Inland Wetland and Water Courses Commission

Application #IWWC22-18URA of Avery Brook Homes, LLC, 1641 Rte. 12, Gales Ferry, CT 06335 for URA activities associated with the siting of new single-family homes with associated grading and utilities on 9 of 36 lots in a proposed 8-30g Re-Subdivision located on 94,96,98 and 100 Stoddards Wharf Rd, Ledyard CT.

PLAN SHOWING RESUBDIVISION PROPERTY OF AVERY BROOK HOMES LLC 94, 96, 98 AND 100 STODDARDS WHARF ROAD A.K.A. CONNECTICUT ROUTE 214 LEDYARD, CONNECTICUT SCALES AS SHOWN JULY 2022

PLAN / PROFILE
 SHOWING
 PROPERTY OF
 AVERY BROOK HOMES LLC
 STODDARDS WHARF ROAD
 LEDYARD, CONNECTICUT
 SCALE: 1"=40' HORIZ.
 1"=4' VERT.

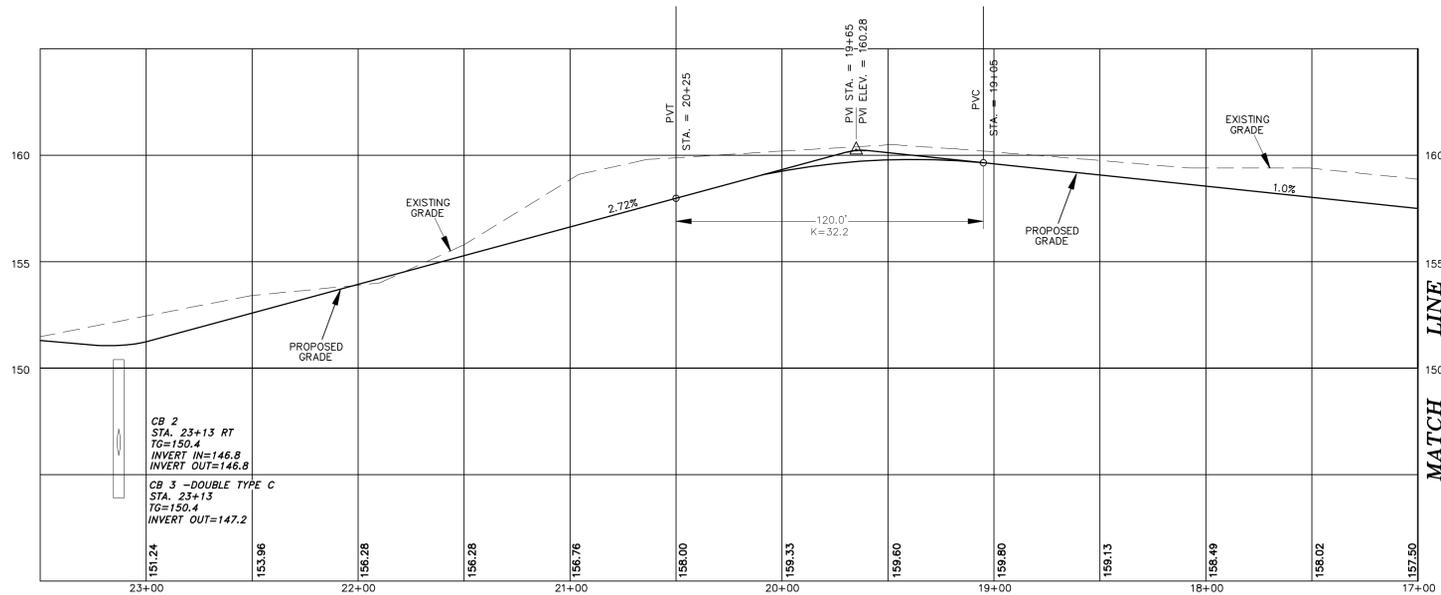
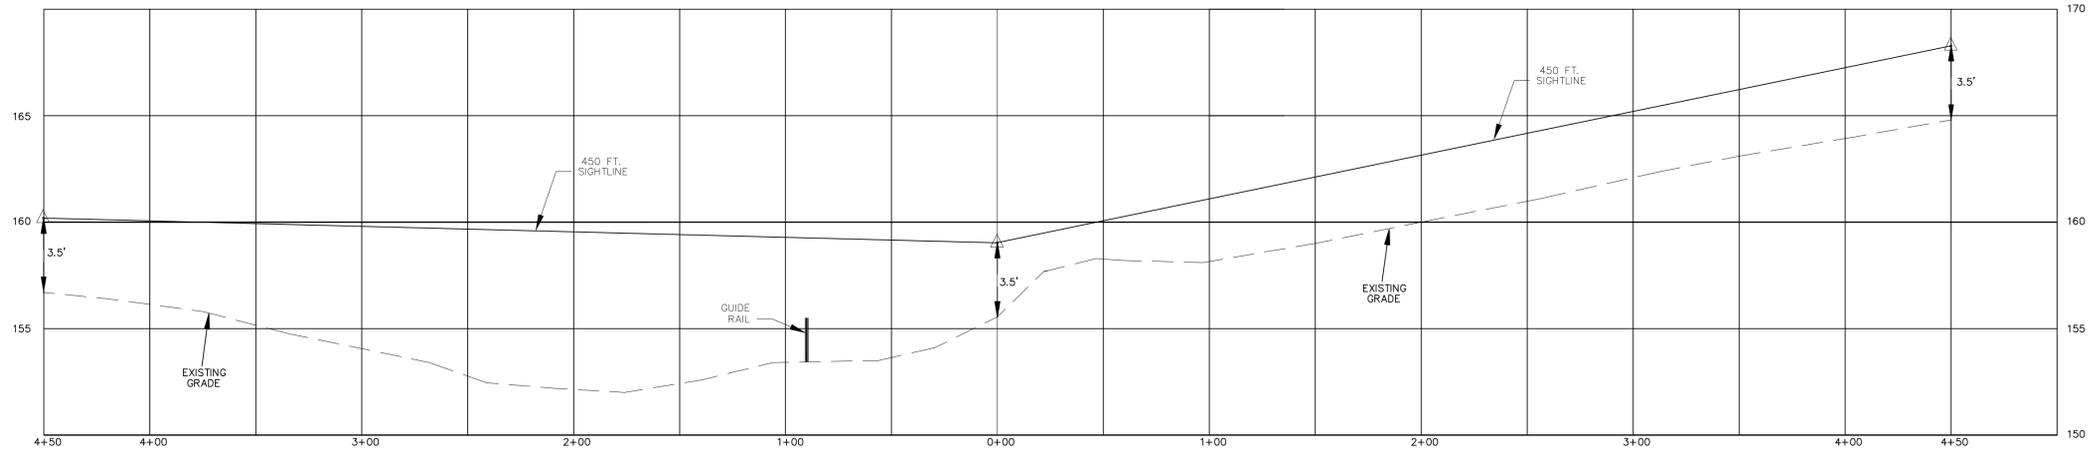
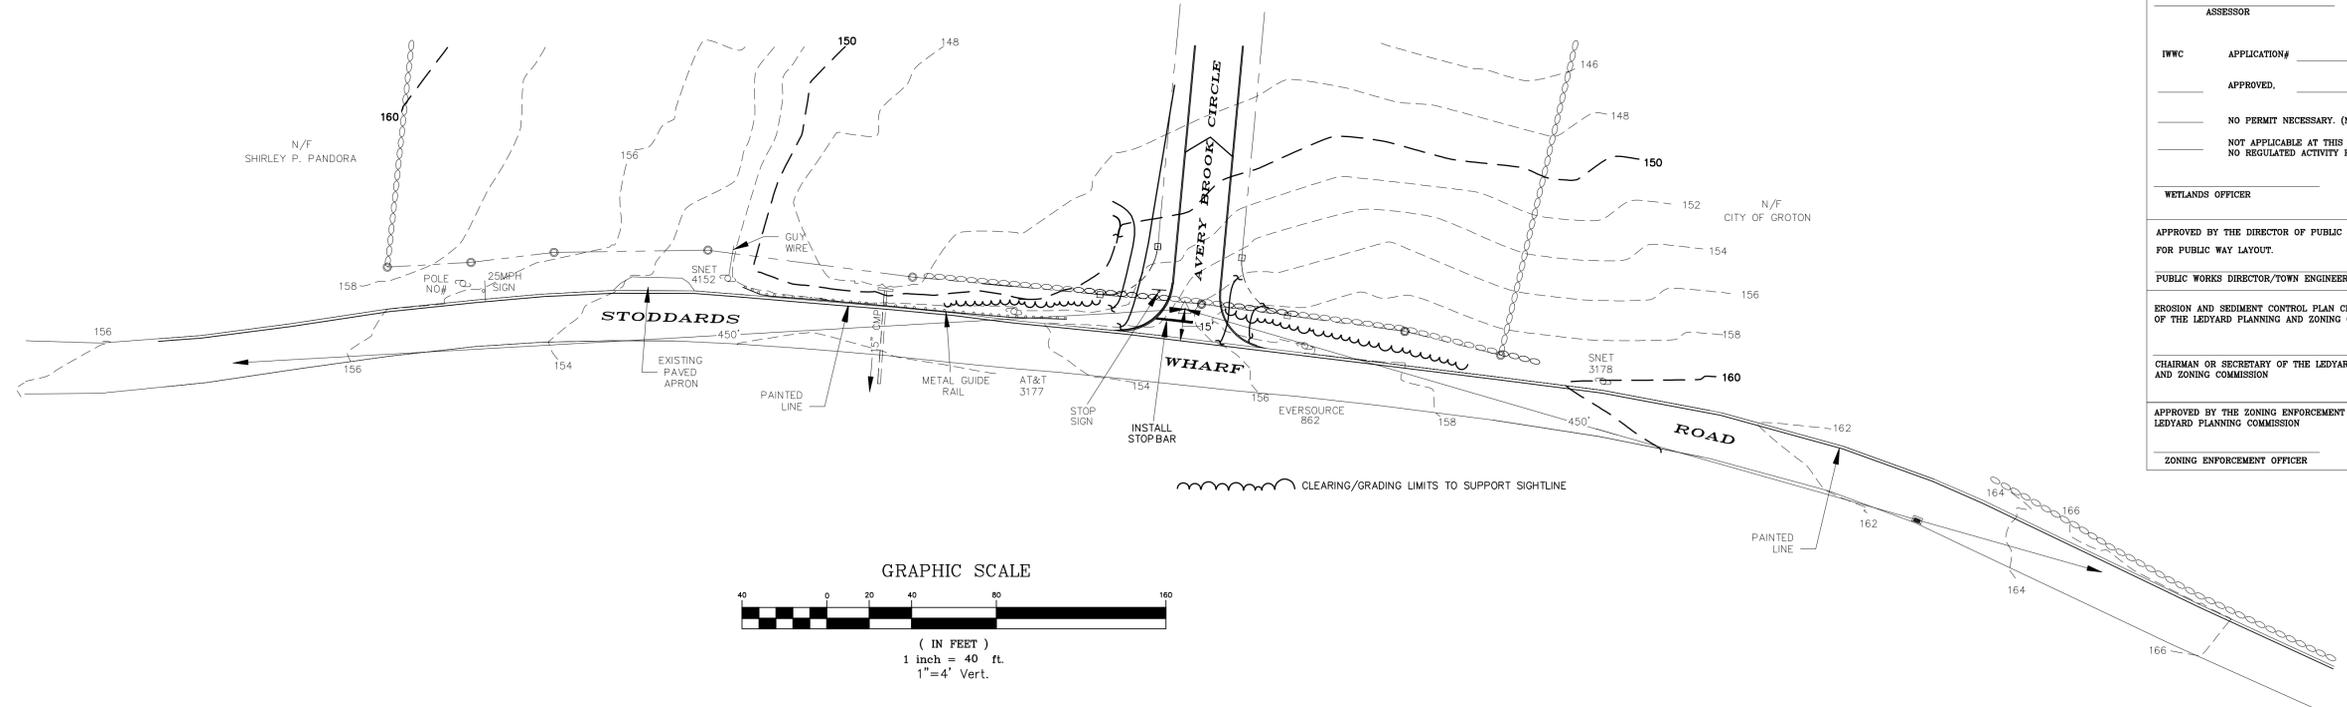
- 2) "The Town will install the required road signage and markings, the cost of which will be backcharged to the applicant/owner."
- c. Sheet 6
 - 1) There is a curbing gap between stations 12+80 and 13+50 on the west side of the road that should be annotated for curbing.

- d. Sheet 7: The pipe inverts associated with CBs 2 and 3 appear to be reversed.
- e. Sheet 10
 - 1) For clarity, invert elevations should be added to the D-Box detail.

1. Added general note 8) re: parking signs
2. Added general note 9) re: actual conditions
3. Added general note 10: re: signage
4. Sheet 6 added curbing 12+80 – 13+50 west, corrected discharge invert
5. Sheet 7 pipe invert revised
6. Sheet 10 inverts added to D-box detail and removed scour hole detail
- 7. Revision to report to address pipe length CB1 to discharge and pipe slopes (attached)

BOUNDARY AND SOILS MAP
THIS IS NOT A SURVEY

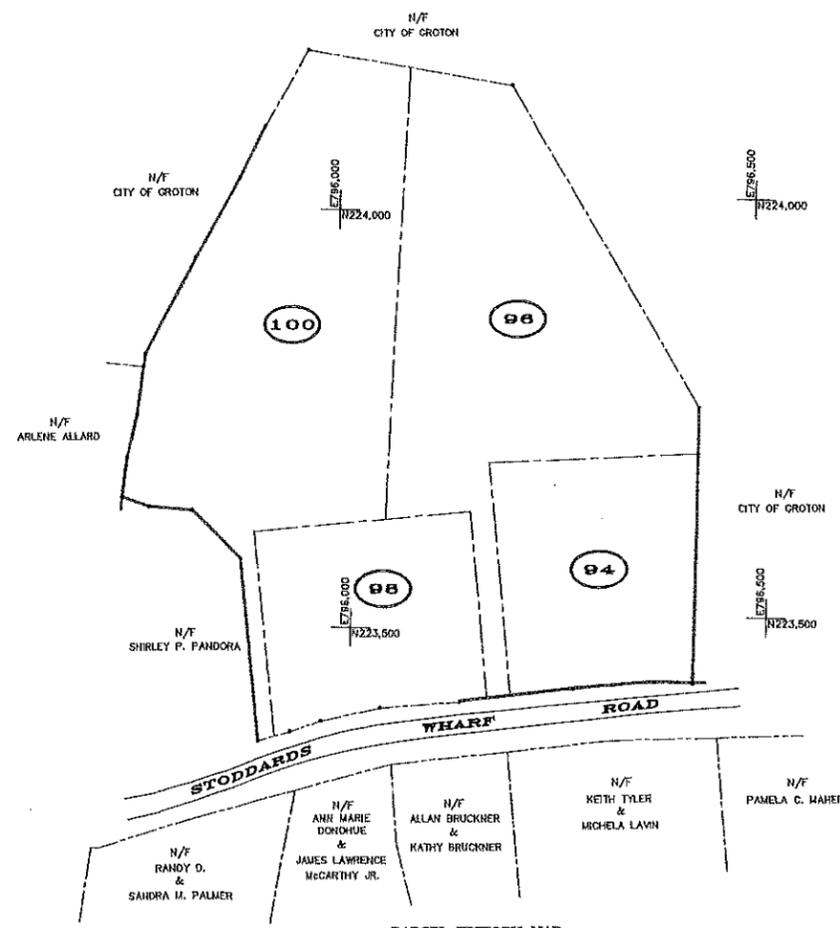
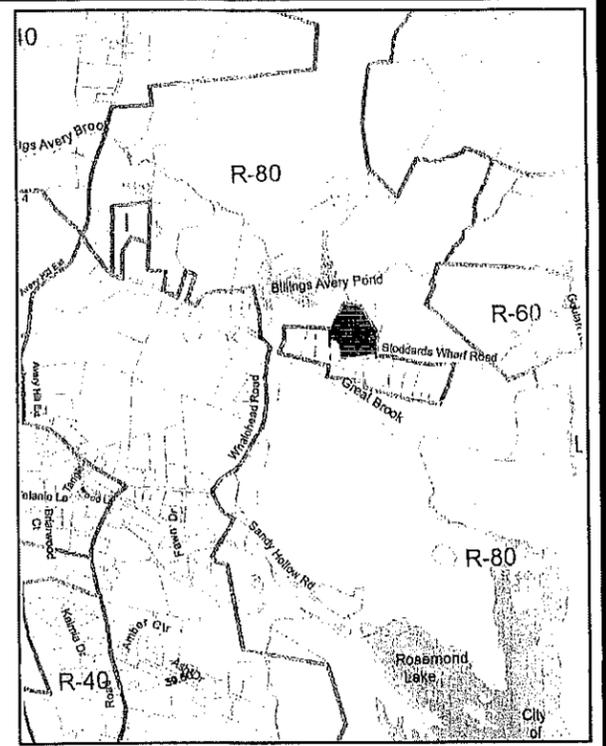
18. The front and rear setback lines specified in General Note #6 (Sheet 1) don't match the building line setbacks depicted on the plans (Sheet 3).
19. How will property line monumentation be provided within the centerline of the new roadway?

- b. Sheet 1: The following general notes should be added:
 - 1) "Actual conditions that develop or are more clearly assessed during construction may dictate that field adjustments, including additional drainage and sightline measures, may be necessary for adequate stormwater management. Additional design effort for and installation of such measures shall be undertaken in accordance with direction from the Town."

10. THE TOWN WILL INSTALL THE REQUIRED ROAD SIGNAGE AND MARKINGS, THE COST OF WHICH WILL BE BACKCHARGED TO THE APPLICANT/OWNER.
